ADDENDUM NUMBER 1

Date: April 6, 2022

Re: North Brunswick High School HVAC
South Brunswick High School HVAC
West Brunswick High School HVAC
Brunswick County Schools
Proj. Number: PC21P0006

Submitted By: Danny Wilds, PE, LEED AP
Mechanical Design, Inc.
4403 Broad River Road
Columbia, S.C. 29210
(803)730-0016 | danny@mdi9834.com

NEW STEEL ANGLE UNIT SUPPORT

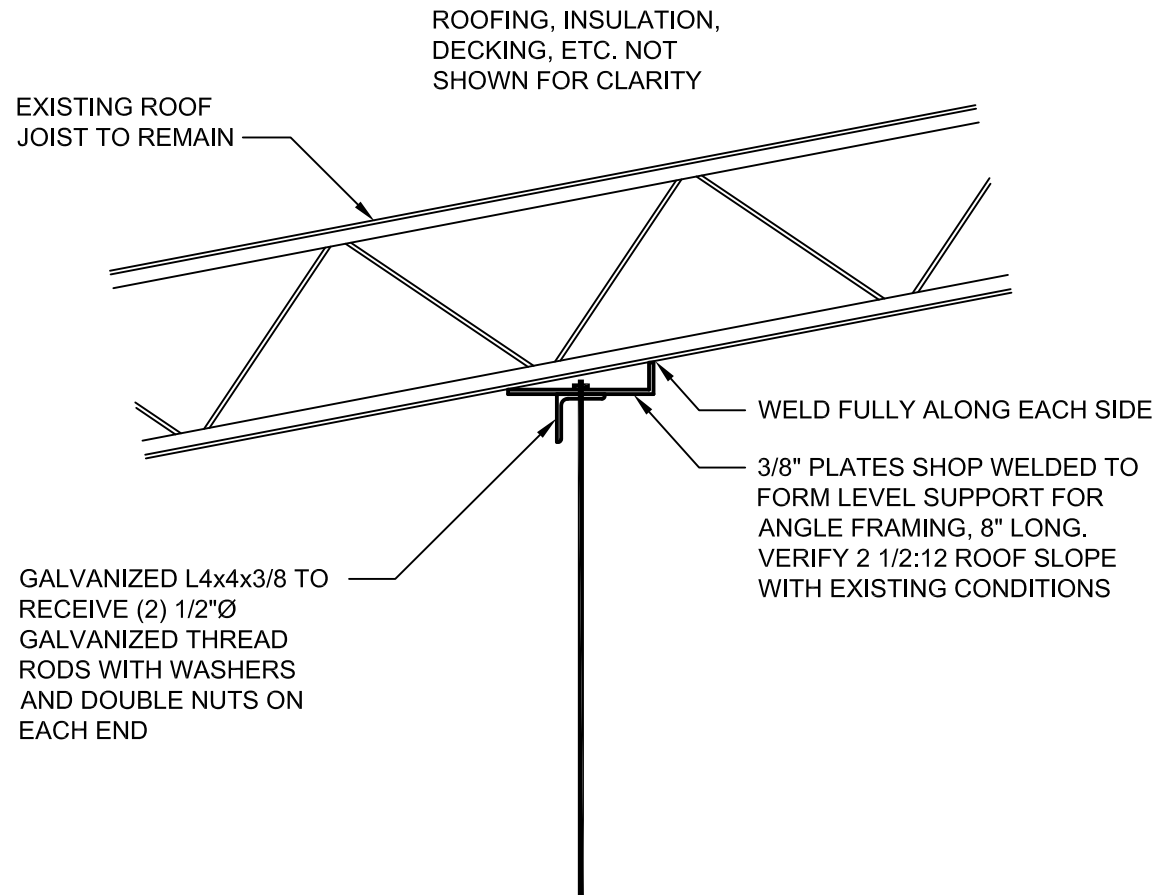
3. Refer to drawing M202 for all (3) high schools, DOAS UNIT ABOVE CEILING DETAIL. Refer to the attached NEW STEEL ANGLE UNIT SUPPORT for connection of hangers to the existing roof joists.
